WORK CHANGE DIRECTIVE (WCD) NO. 2

PROJECT: Phase 2 Reconstruction of Turner Street and Butler Road Project – RE1902A

Work Change Directive #2 is issued in connection with Lucas's submitted CPR #2 – Fire Station Access Drive. The proposal provides for the construction of a reinforced concrete access drive serving the fire station, including site preparation, lime stabilization, reinforced concrete paving/driveway, sod placement, and associated bond costs. The total proposed cost of this work is $63,875.00.

PLAN & PROFILE
TURNER ST
BEGIN TO STA 6+00

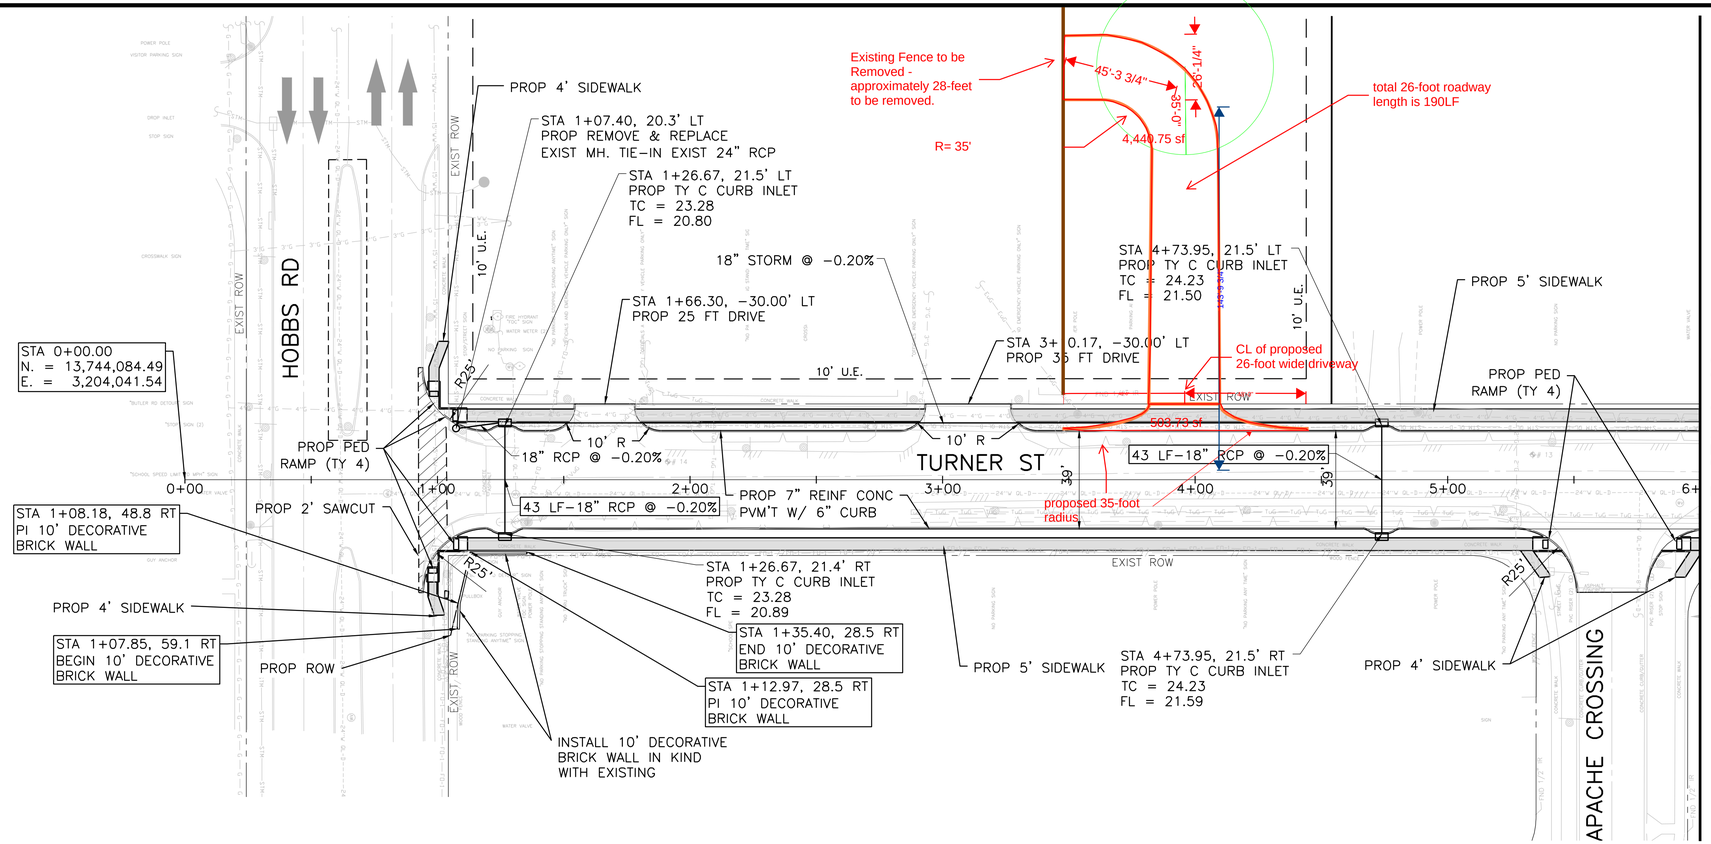
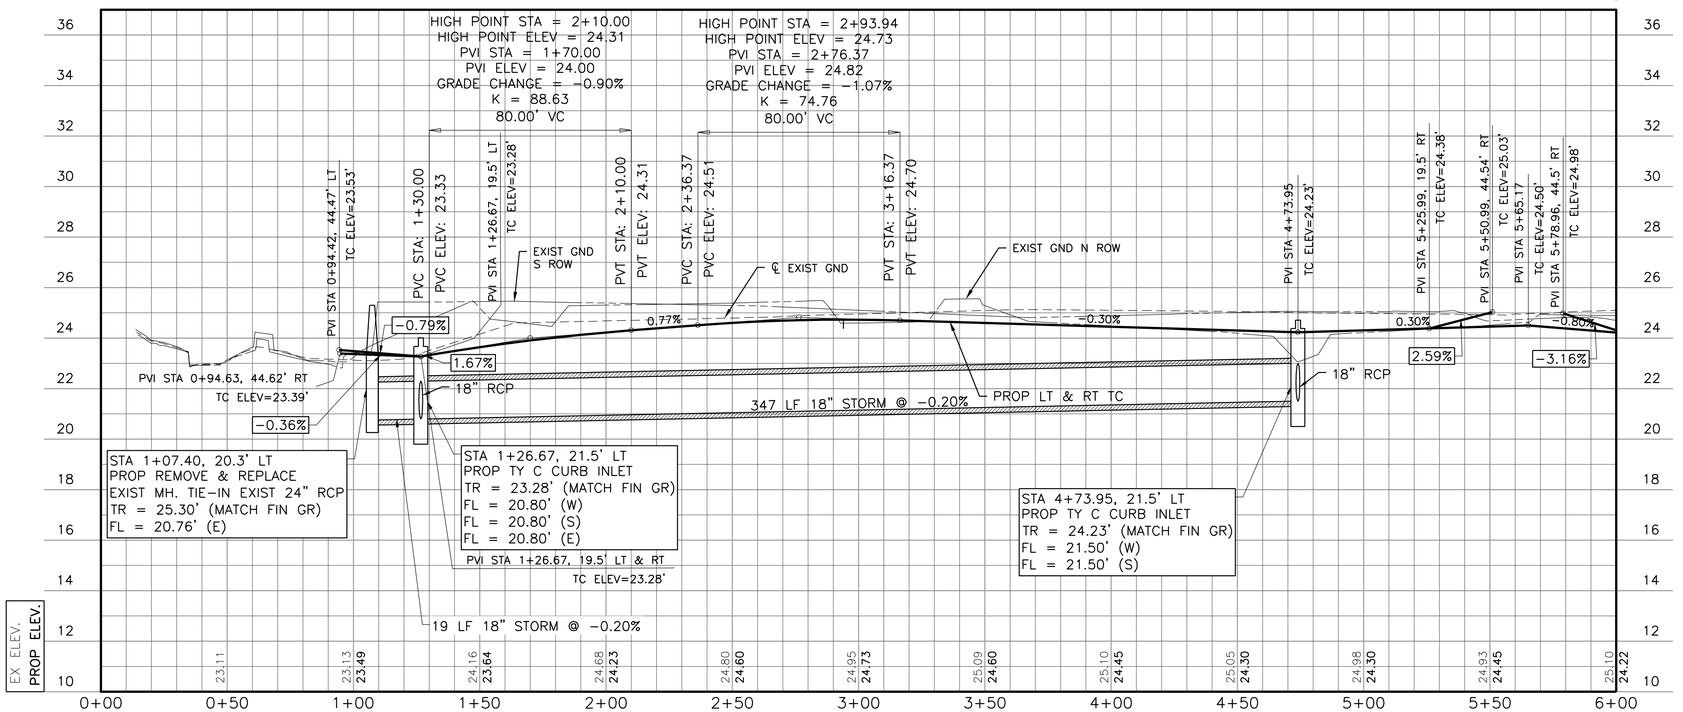
In response to the request to add a concrete access drive for the fire station located on Turner St., Lucas Construction Company, Inc. proposes to provide labor, materials, equipment, layout, supervision, and insurance to accomplish the additional work for the following amounts:

-Site prep, including layout, stripping and disposing of existing vegetation, excavation/embankment, and grading	$8,750
-Lime stabilize 8” deep at a rate of 8% by dry unit weight	$10,010
-Furnish and install 7” reinforced concrete paving	$36,000
-Furnish and install 7” reinforced concrete driveway	$8,265
-Block sod	$1,200
-Bond	$700
-Delete 15 SY of sidewalk	($1,050)
